Proposed Changes
Sector Plan & Zoning Ordinance Maps
Draft 2/4/22

Proposed Map Changes- Block Key Map (Map 2.2)

Draft 2/4/22

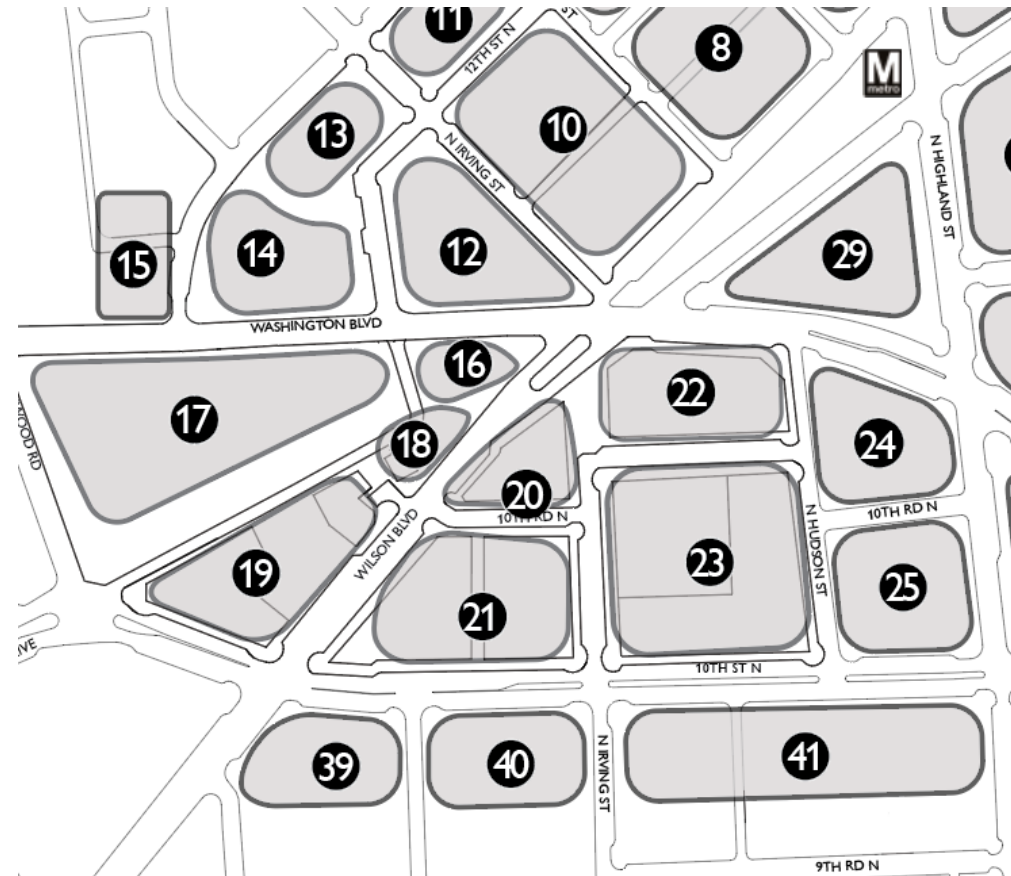
- Proposed street alignment/ locations

Proposed Map Changes- Density (Map 2.3)

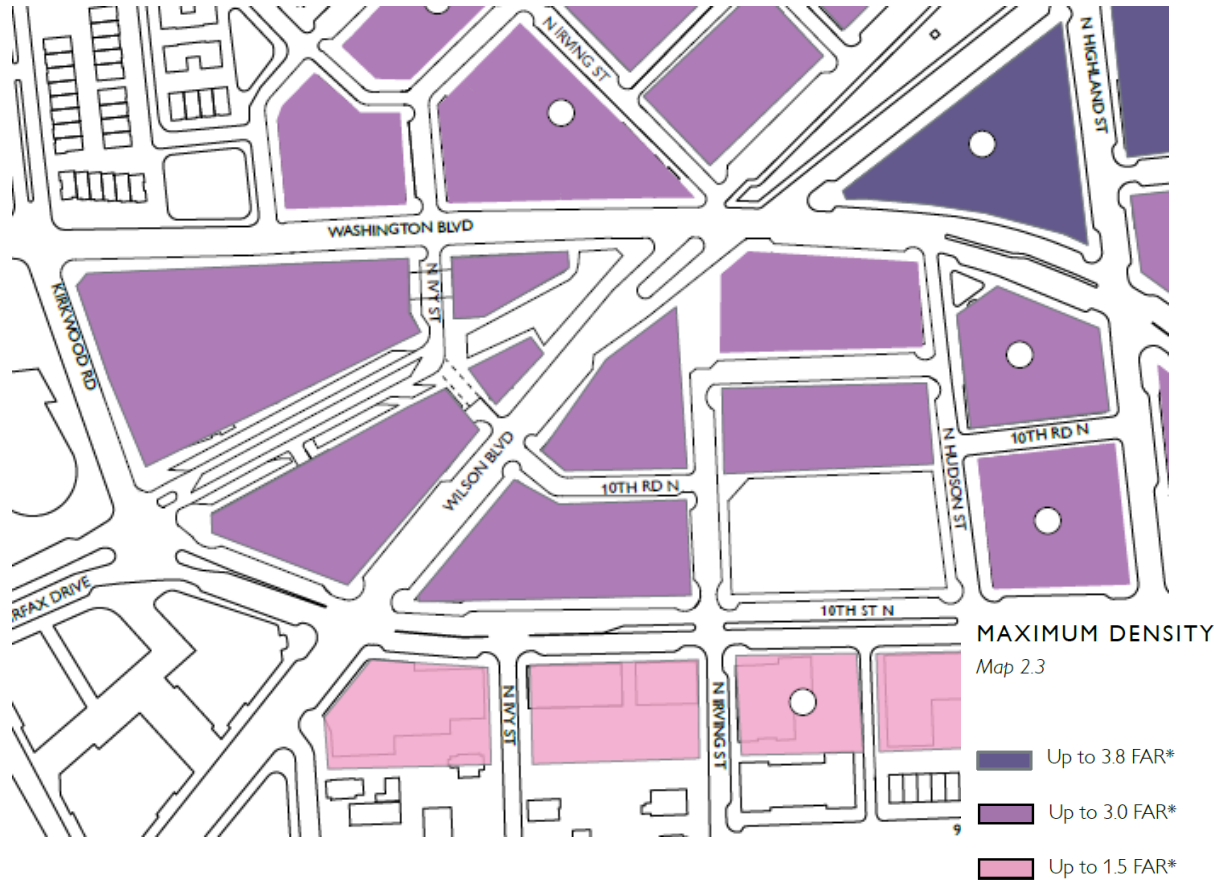
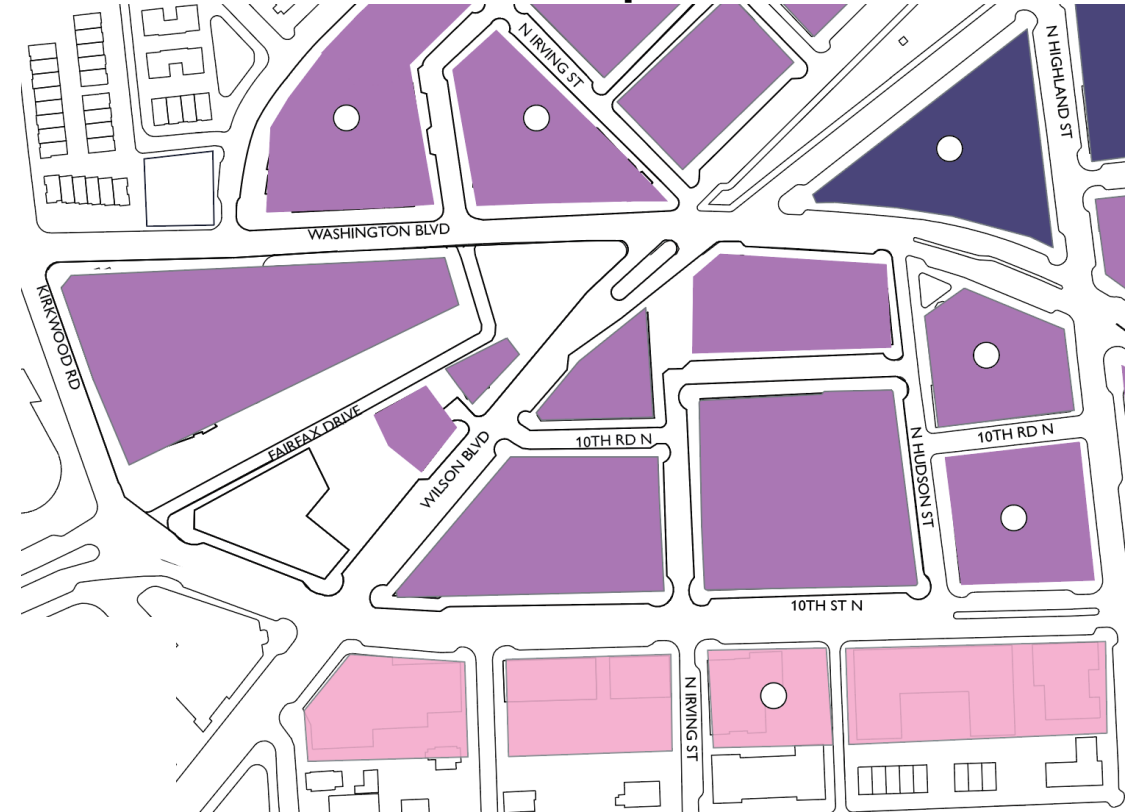
- Removal of Dominion Substation & Triangle Park density

Proposed Map Changes- Receiving Sites (Map 2.4)

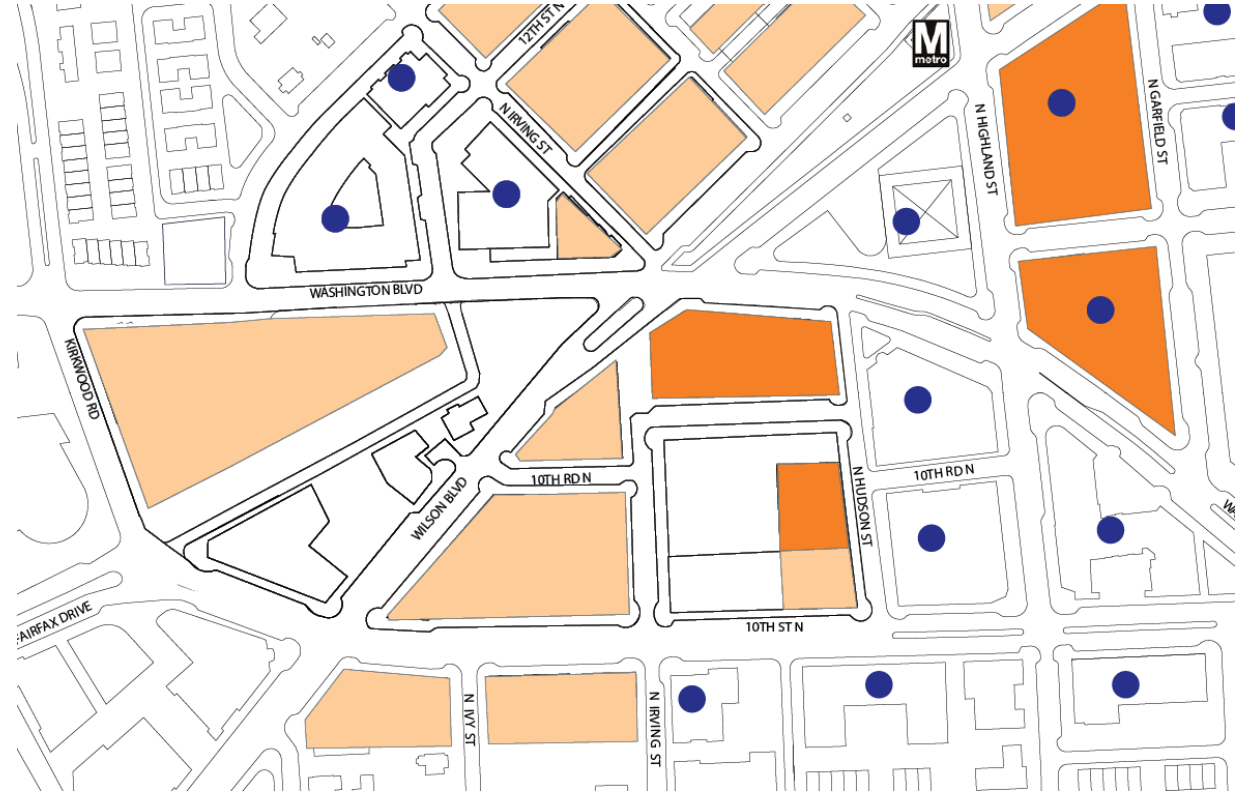
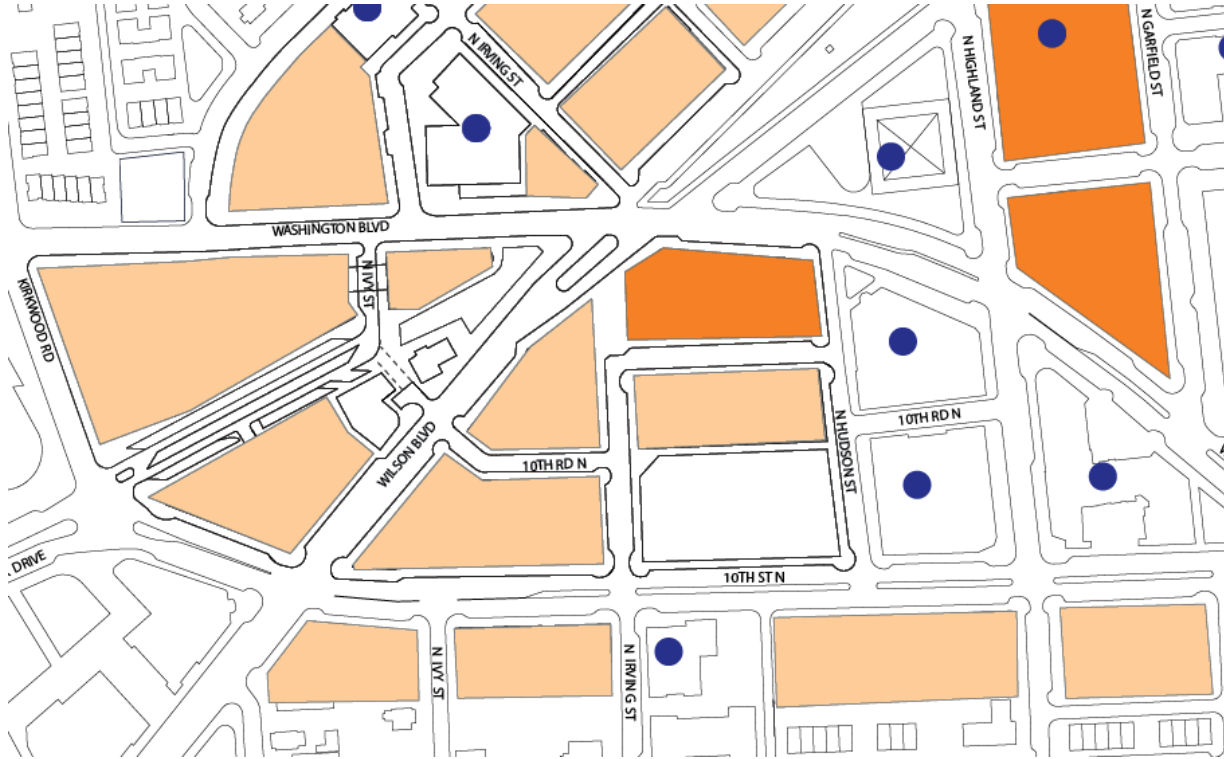
- Removal of Verizon, Dominion Substation & Triangle Park as receiving sites for density

Proposed Map Changes- Use Mix (Map 2.50)

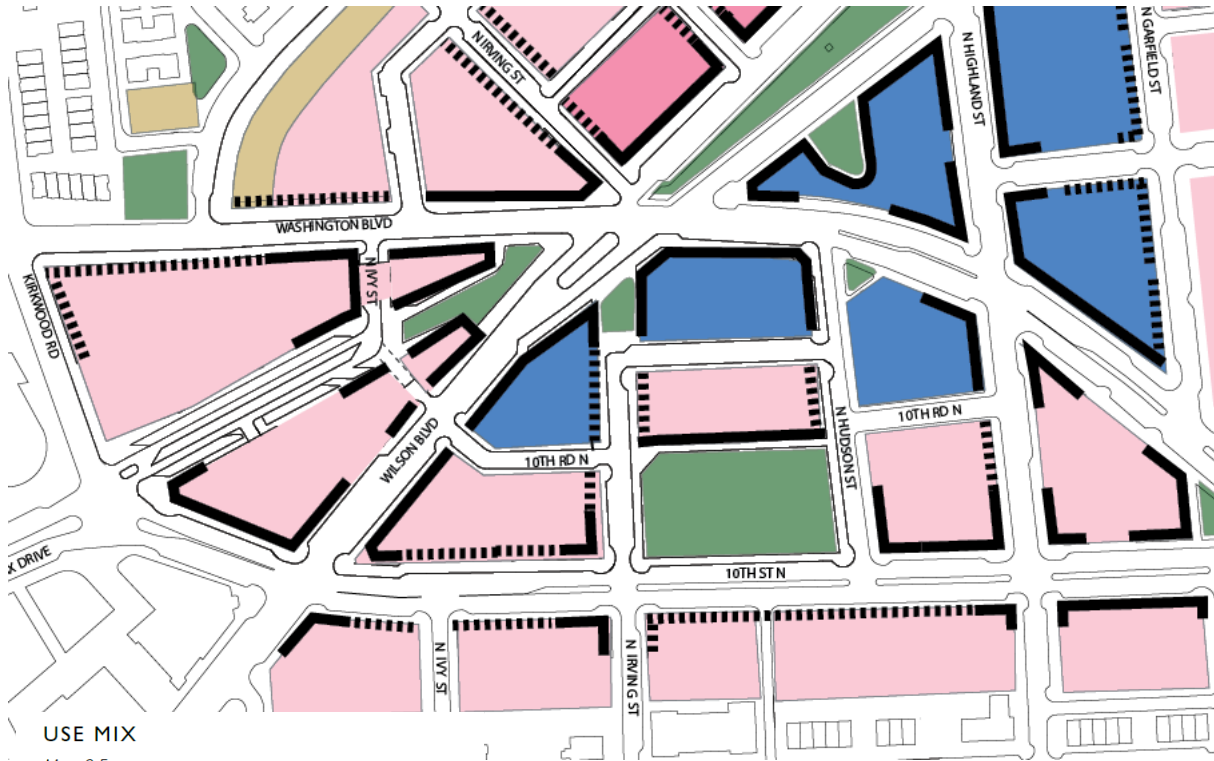
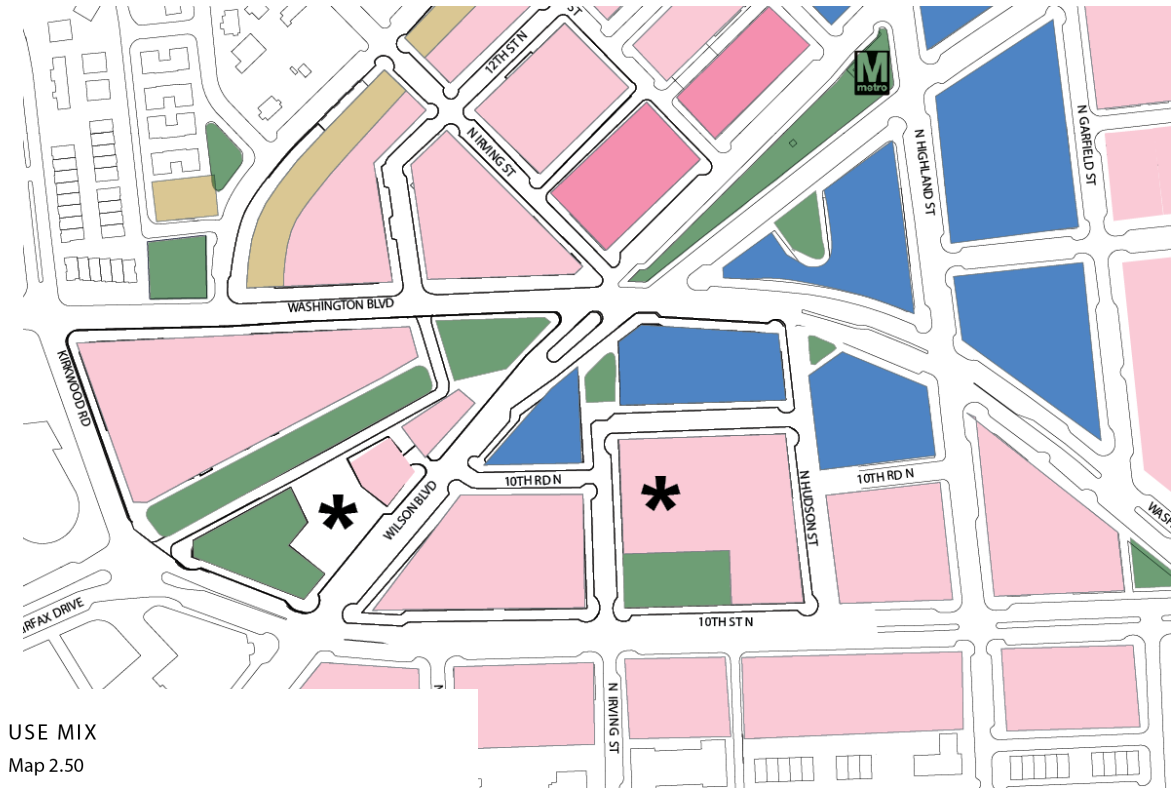
- Remove retail frontage lines from the map & legend
- Retail frontage would become a separate map in CSP

- Add symbol for existing utilities (Verizon & Dominion Energy)
- Add reference note to Retail Plan & New Retail Frontage Map (in Sector Plan only)

Proposed Map Changes- Building Height & Step-backs (Map 2.7)

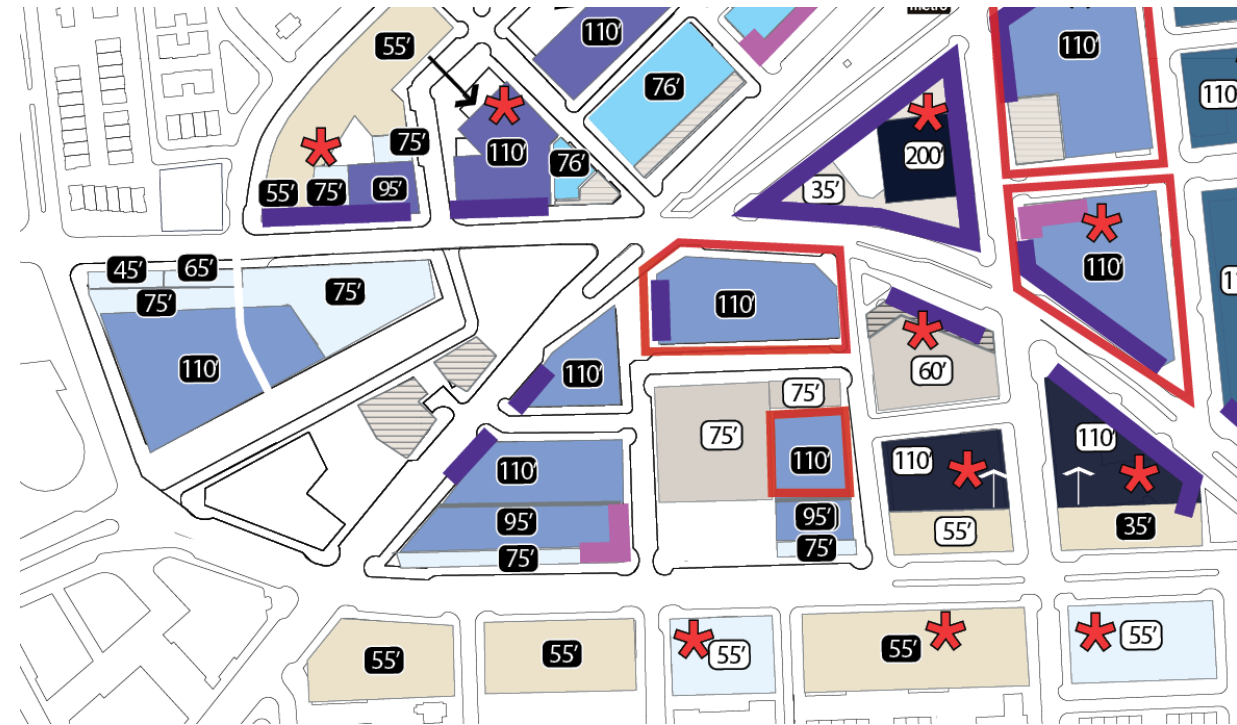
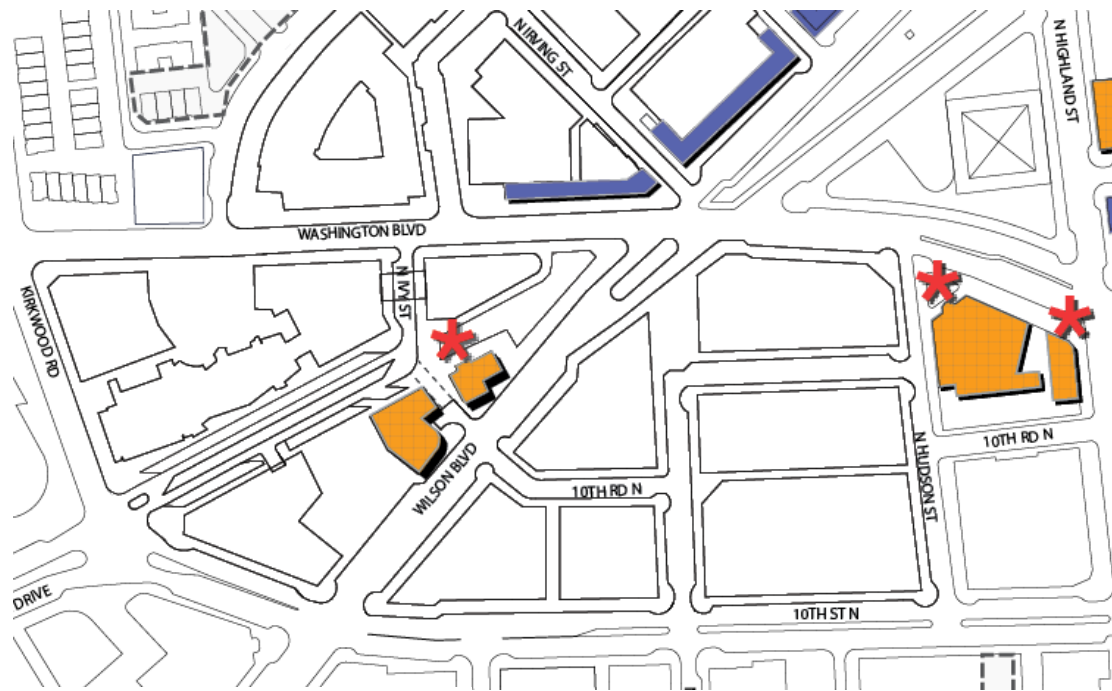
• Combined Height & Step-back Maps

Designated frontages for step-backs where building height exceeds 60'- Step-back 10' at the 2nd, 3rd, 4th or 5th floor

Designated frontages for step-backs achieved through building façade or building frontage preservation- 10'

Proposed Map Changes- Building Preservation (Map 4)

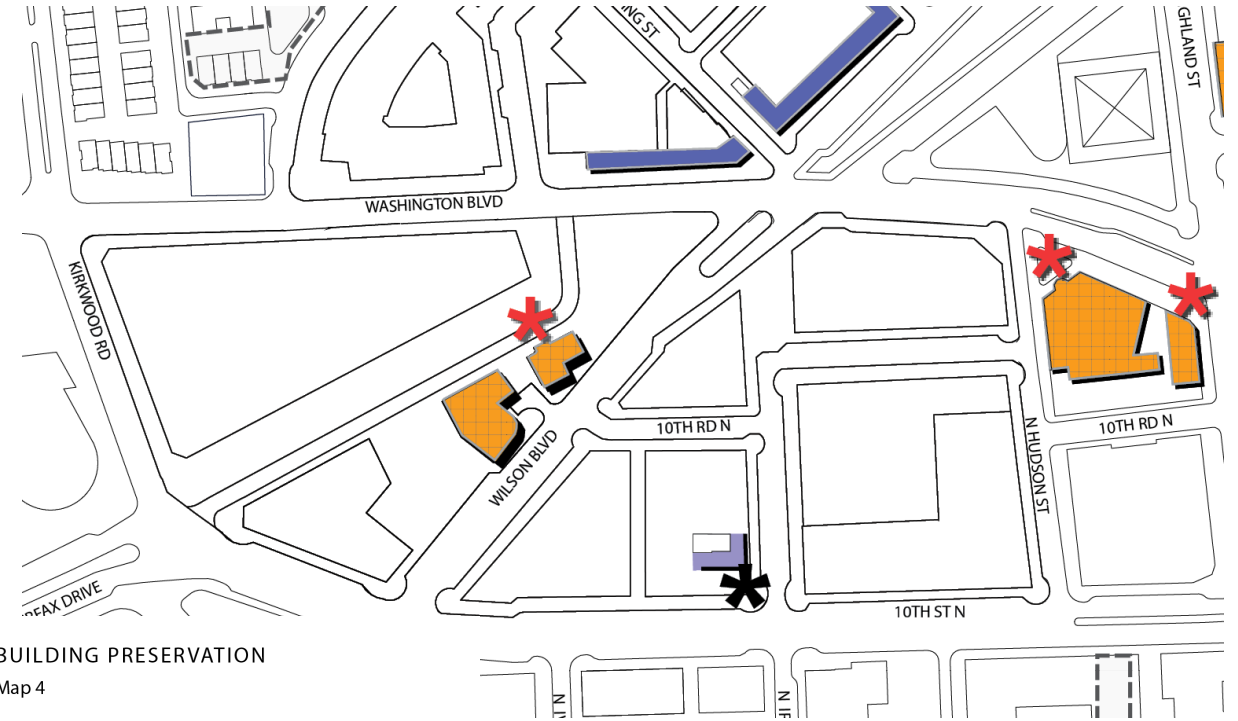
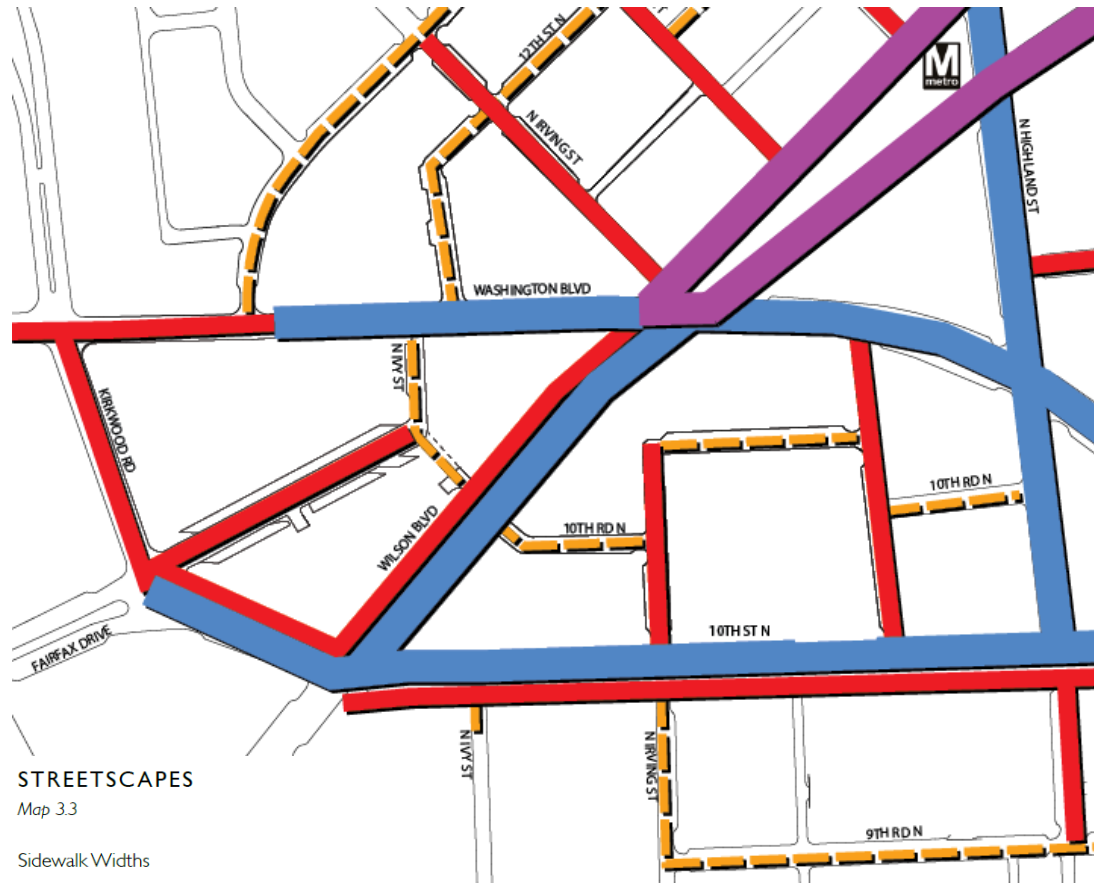
- Addition of Façade Preservation of Joyce Motors to map
- Added symbol & note in legend for façade relocation
